NOTICE OF DECISION
Catalyst High School Addition – 1421 N Deborah Road
Design Review – DR221-0010

DECISION AND FINDINGS
Catalyst High School Addition – 1421 N Deborah Road
Design Review – DR221-0010

REQUEST: Approval of a 13,440 square foot addition.

SITE PLAN- BASE BID +
BID ALT

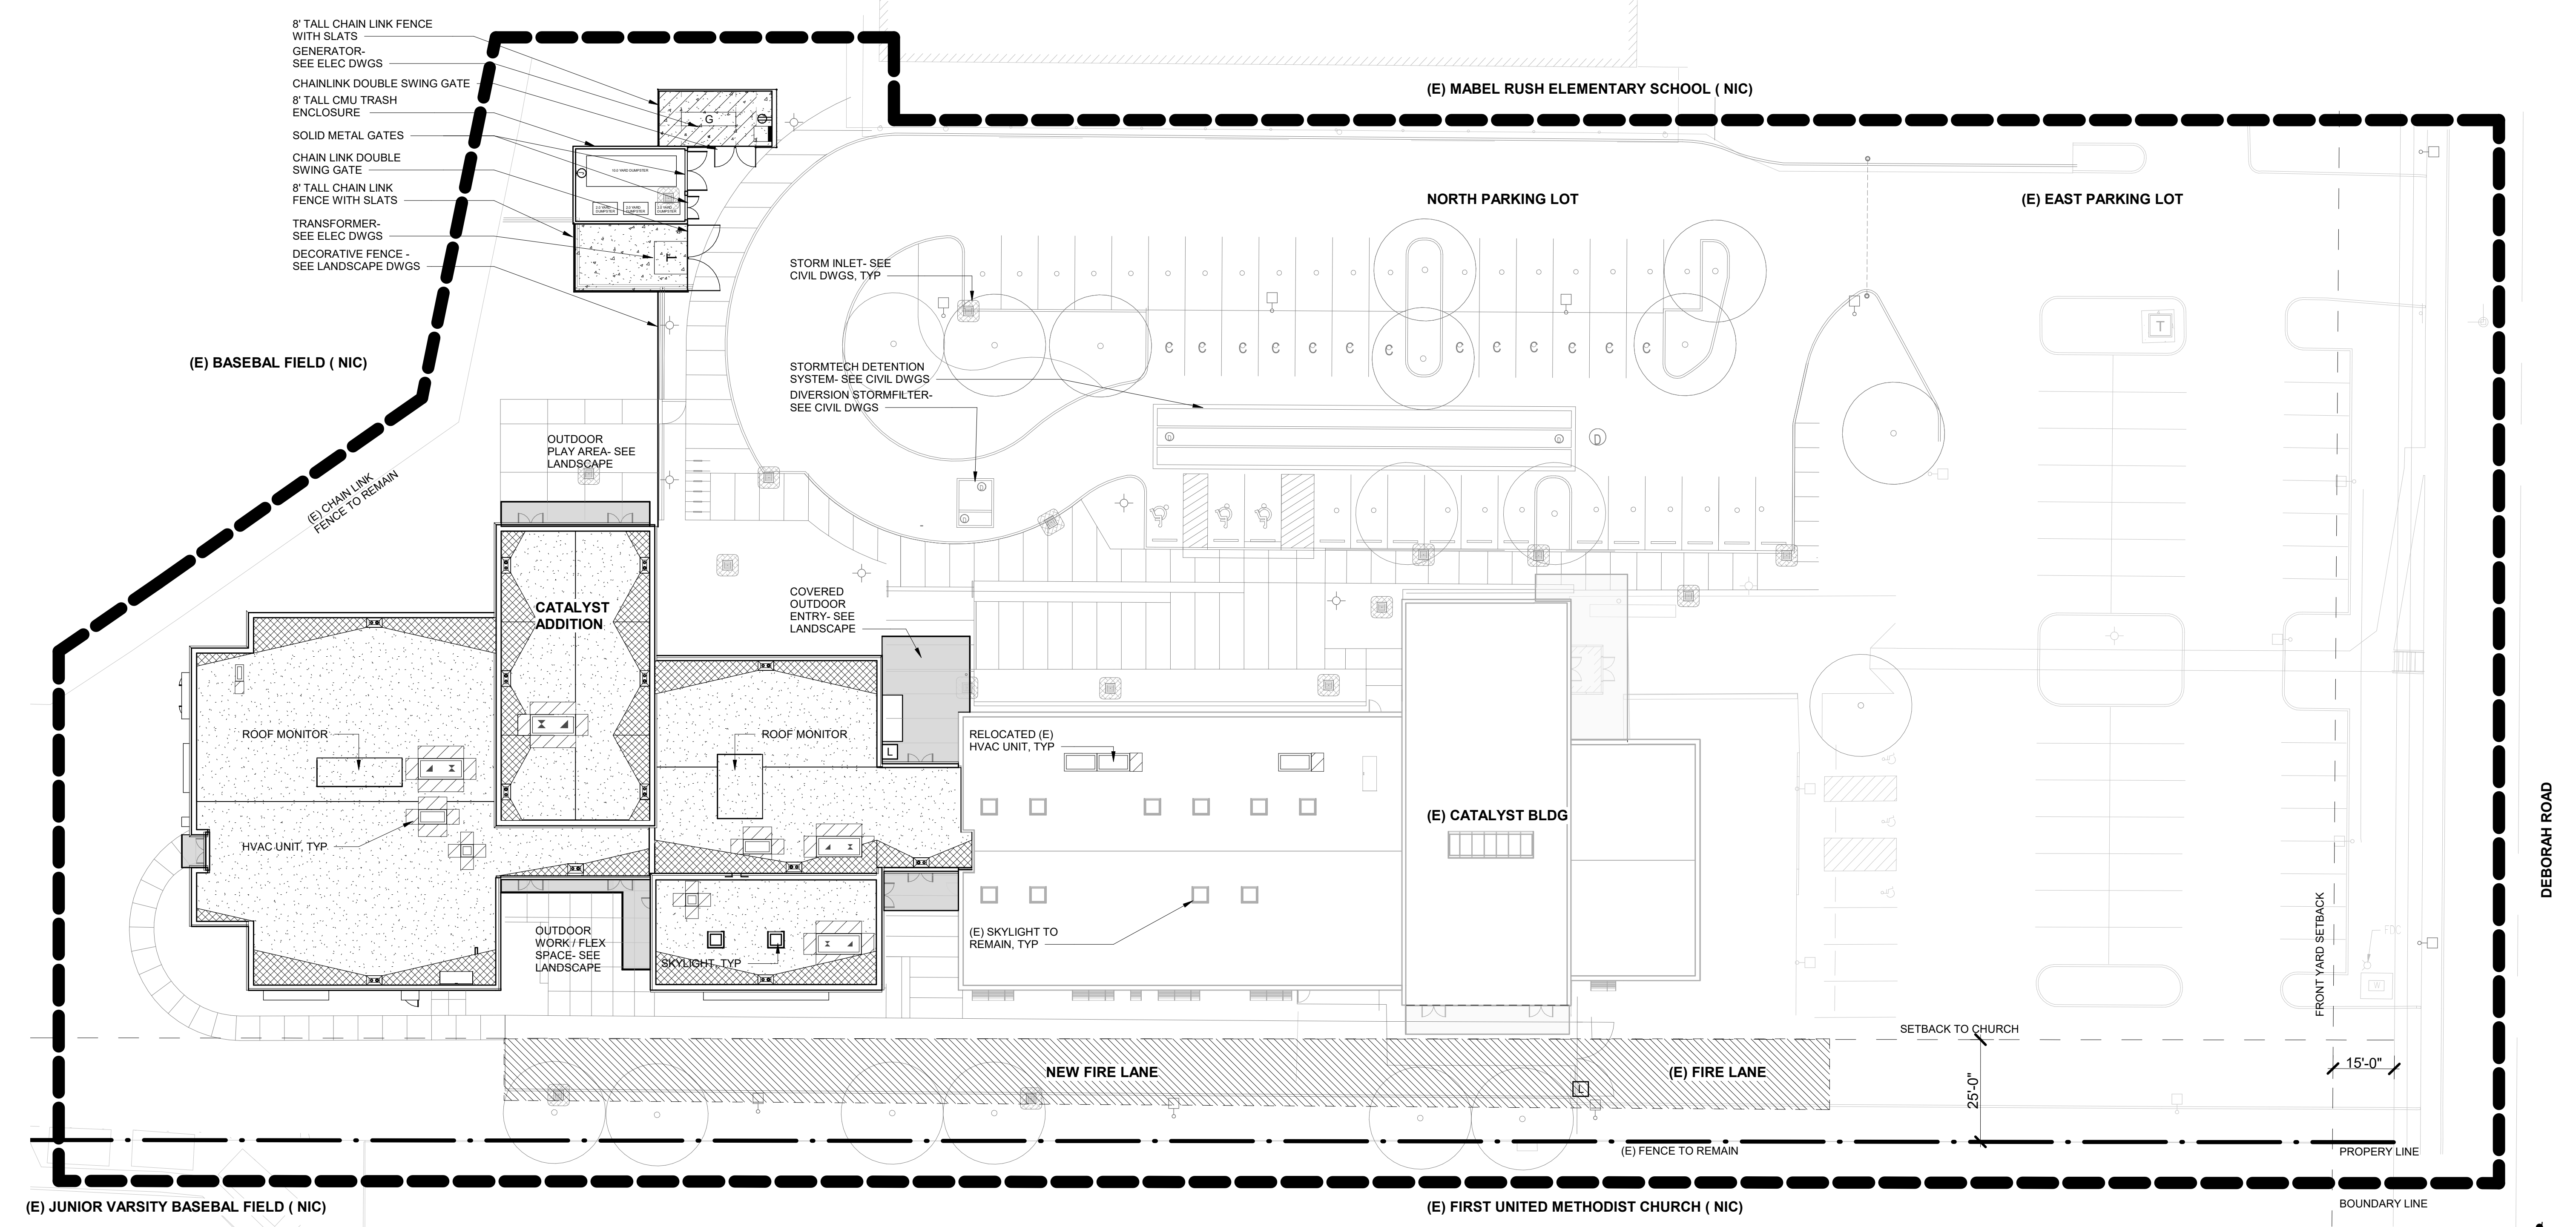
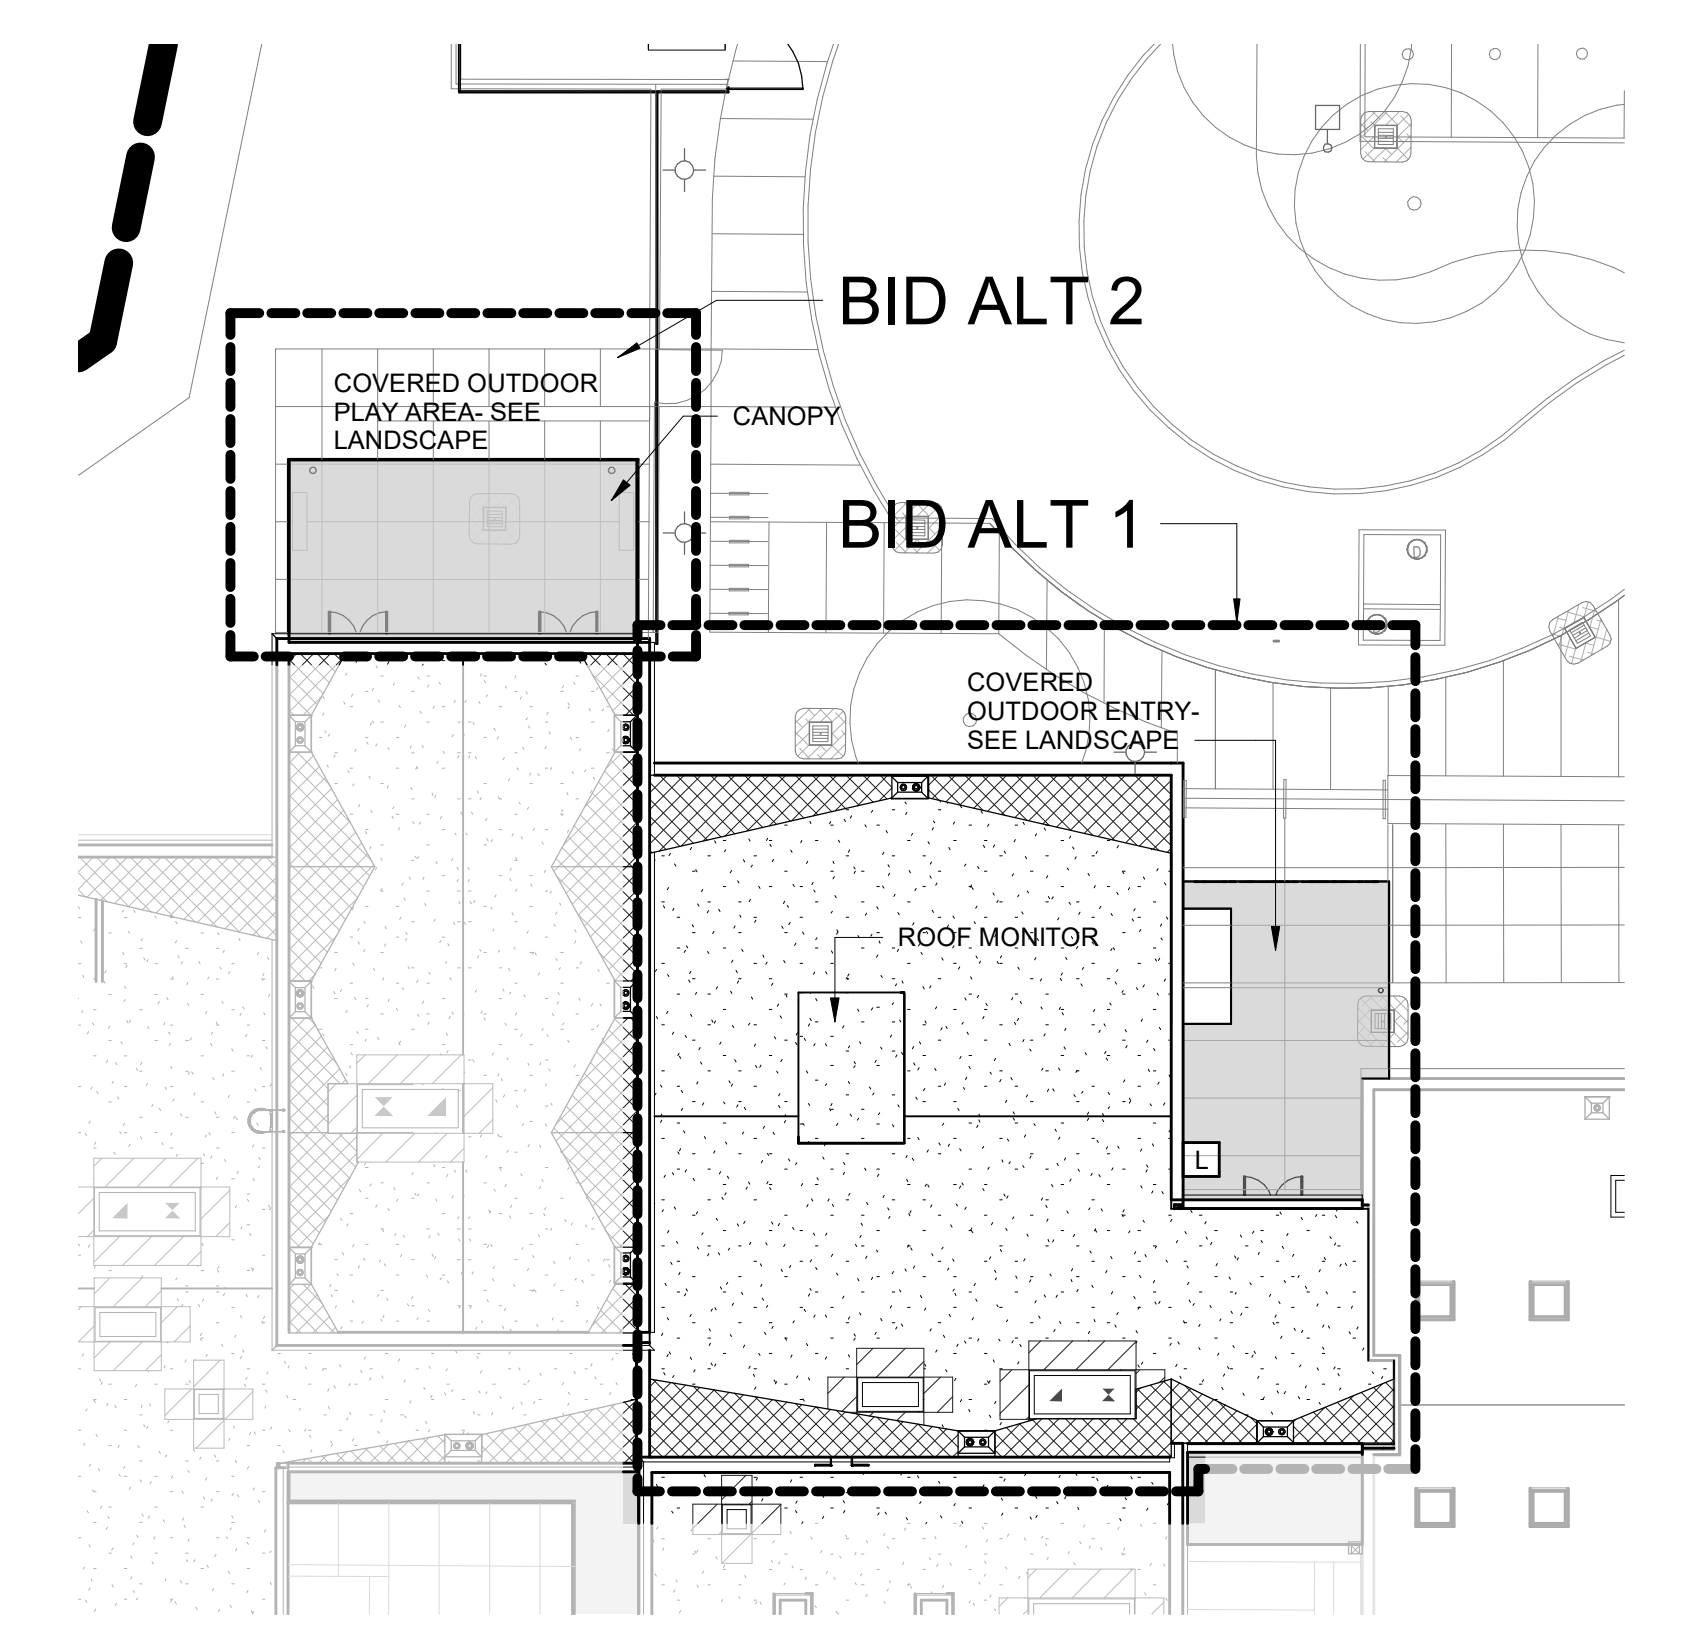
8. Public Works Maintenance Superintendent: Commenting on Sheet A1.01 “Storm water filter detention is to be privately maintained annually in order to meet the city’s TMDL (Total Maximum Daily Load). See Attachment 2.
9. Public Works Maintenance Supervisor: Reviewed, no conflict.
10. Tualatin Valley Fire and Rescue: Extensive comments. See Attachment 2.

Sheet A1.01
Storm water Filter
Detention is to be
Privately maintained
Annually in order to
meet the city's
TMDL.
